Reviewed by City of Boerne Engineering & Mobility: \_\_\_\_\_  
 Approved for Construction: \_\_\_\_\_  
 Approved as Noted: \_\_\_\_\_  
 Disapproved: \_\_\_\_\_  
 Incomplete - Not Reviewed: \_\_\_\_\_  
 Not Reviewed - Accepted FIO: \_\_\_\_\_  
 By: Cheryl J. Rogan Date: 4/22/2024

# GEORGE'S RANCH

## UNIT 1

# WATER DISTRIBUTION PLAN

# C56

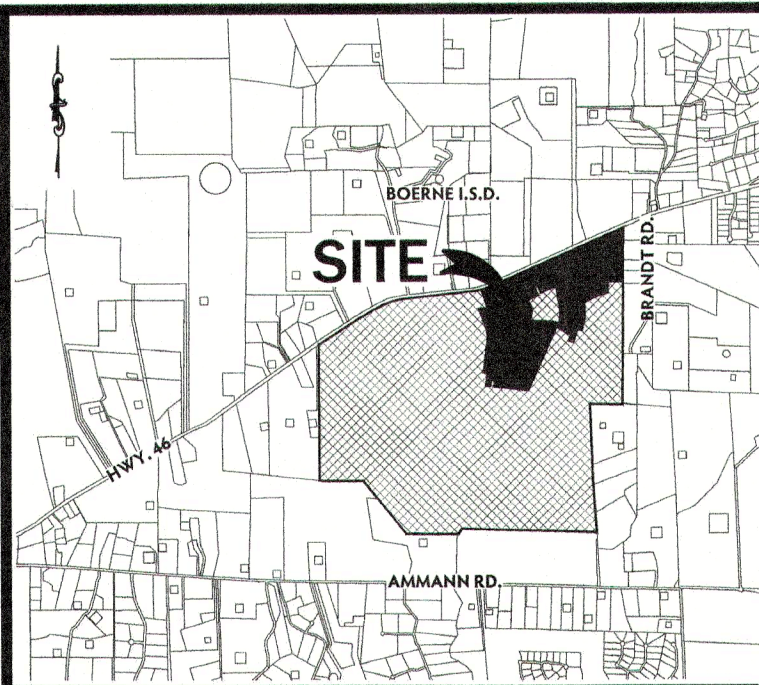
Water service is proposed to serve sales trailer (undeveloped lot); impact fees for water service must be paid prior to setting meter; water service will serve future lot once platted and address is assigned; it is not the responsibility of the City to ensure impact fees are not paid twice
